## ADDENDUM NO. 1

Date of Addendum: April 23, 2015

Project: Henry Miller Area Storm Drain and L Street Waterline

Owner: City of Los Banos

ATTACHMENT 2

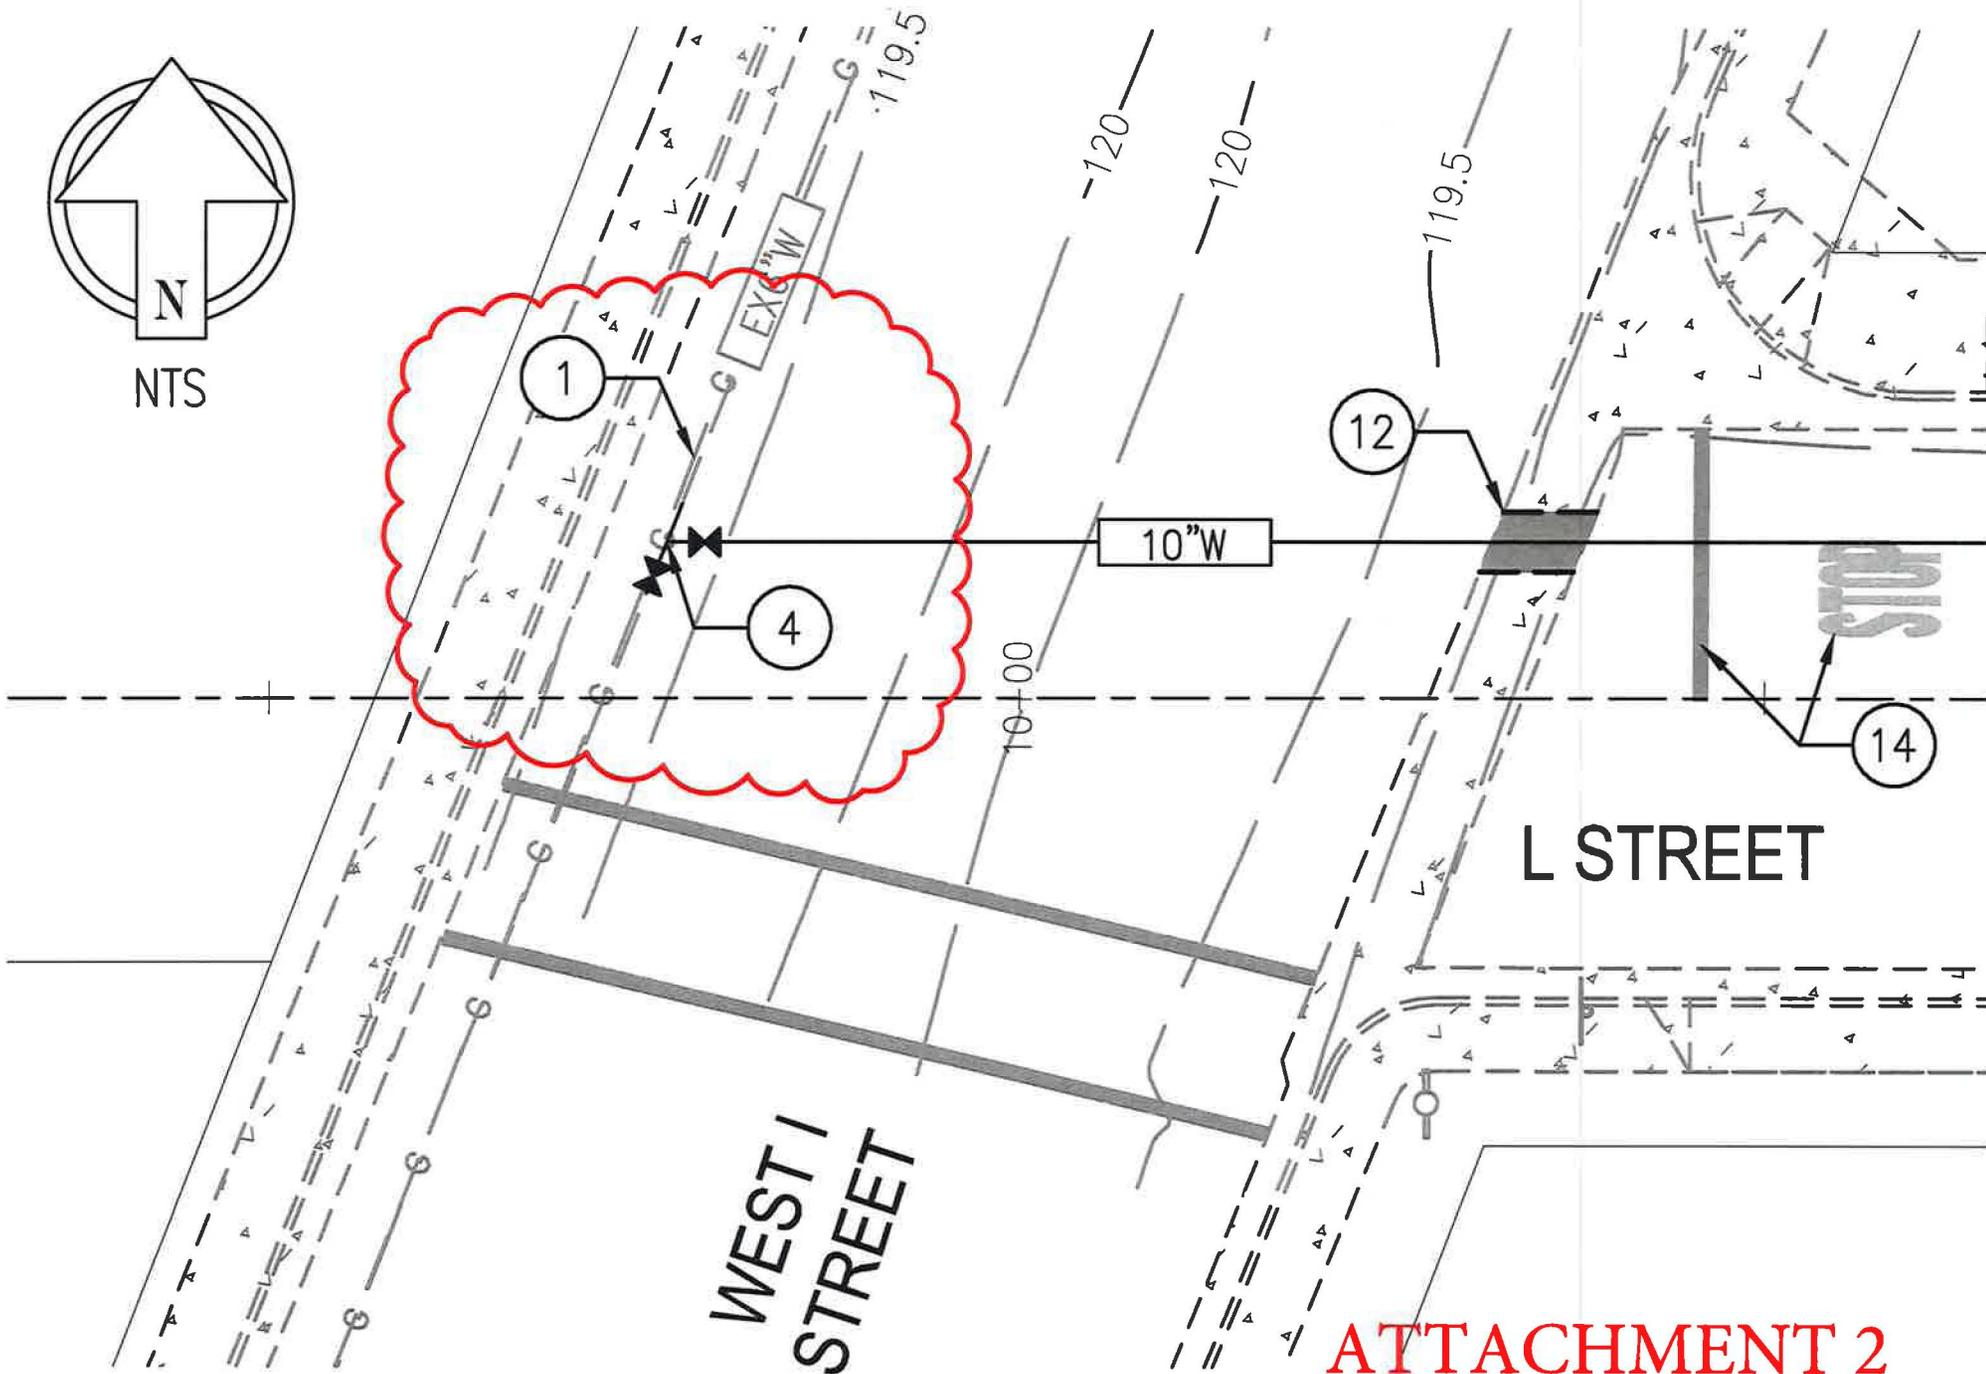
- i. Construction Note 4 on sheet 4 of the Project Plans shall be revised to read: Connect to existing waterline. Remove the existing 6" waterline as required to install a 10" Tee with a 10" to 6" Reducer on the North leg and a 10" to 6" Reducer and 6" water valve on the South leg (Attachment 2).

# ATTACHMENT 3

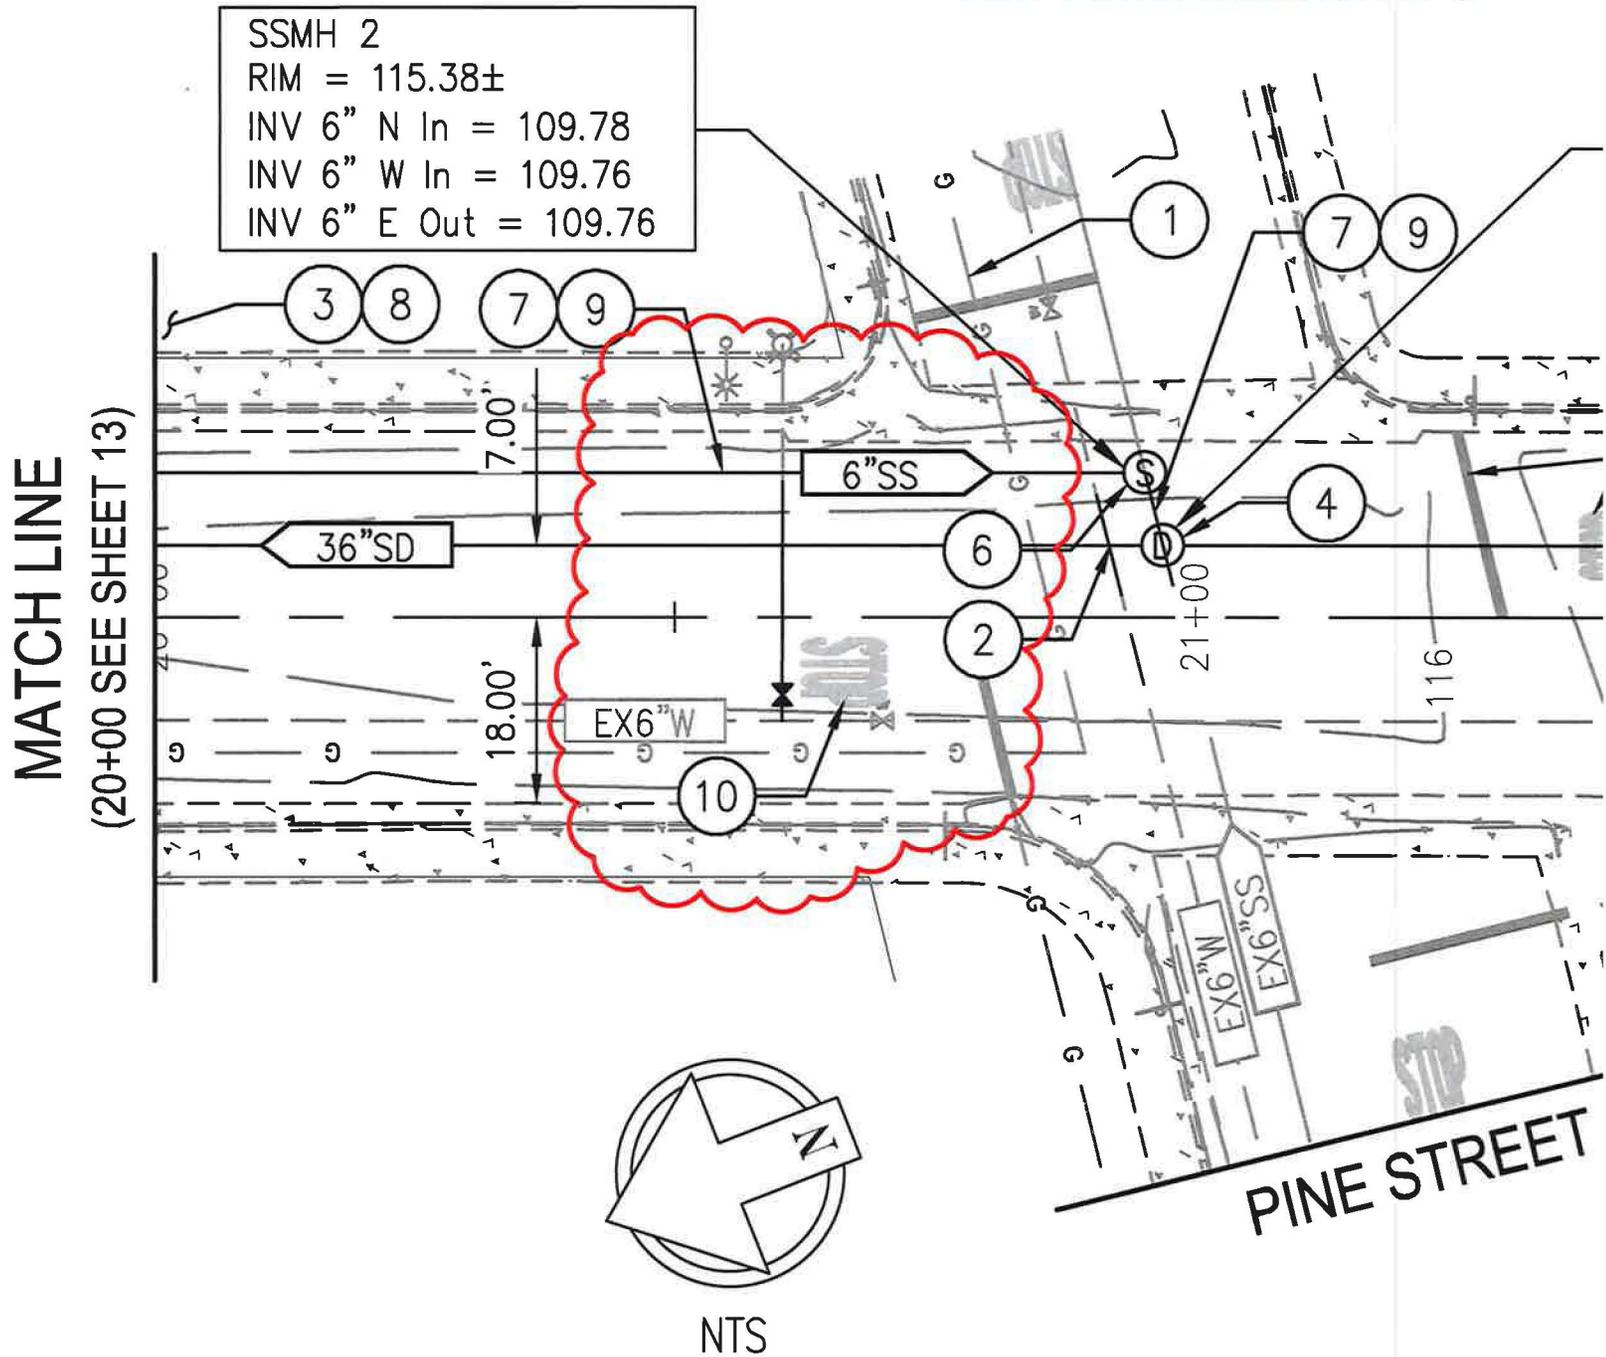
- ii. Plan sheet 14 shall be modified to include the adjustment of this fire hydrant service and the installation of a 6" isolation valve (Attachment 3).

- i. The Bid Item Description for Bid Item 25 – Water Main and Water Service Adjustments, shall be modified to include all work and materials required to reroute the existing fire hydrant service line to avoid any conflict with the proposed Storm Drain Line and installation of a 6" Isolation valve for the fire hydrant service.
